LR Door Seal Improvements LR, LRBE

FSB 845-003, LR Door Seal Improvement

(January 2022).

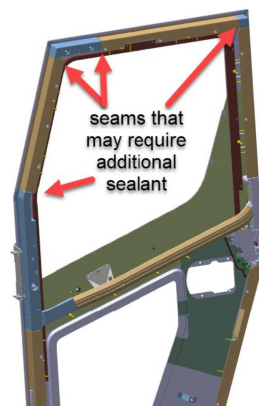
Starting July 5, 2021 an improved primary door seal was introduced into production. The new seal offers a more robust profile that enhances the sealing properties between the door and the cab.

The improved seal has been made backwards compatible to all LR model trucks. If you are experiencing water intrusion around the door area on an LR model built before July 2021, it is advised to install the upgraded primary door seals to correct the concern. It may also be necessary, in some cases, to add additional sealant to the door seams.

Note: In certain instances, there may be a lack of space between the headliner and the improved seal to gain the desired fit. If this situation is encountered the headliner can be trimmed or replaced with current upgraded parts. Reference Function Group 831, Information type Bulletins/Information TPI 831-043, Door Seal for proper seal identification.

If additional sealant is required use 3M 540 Polyurethane Sealant. Follow directions on the product packaging for best results

Sealant locations as seen in the graphic. Same locations on right and left door (right side door shown for reference).
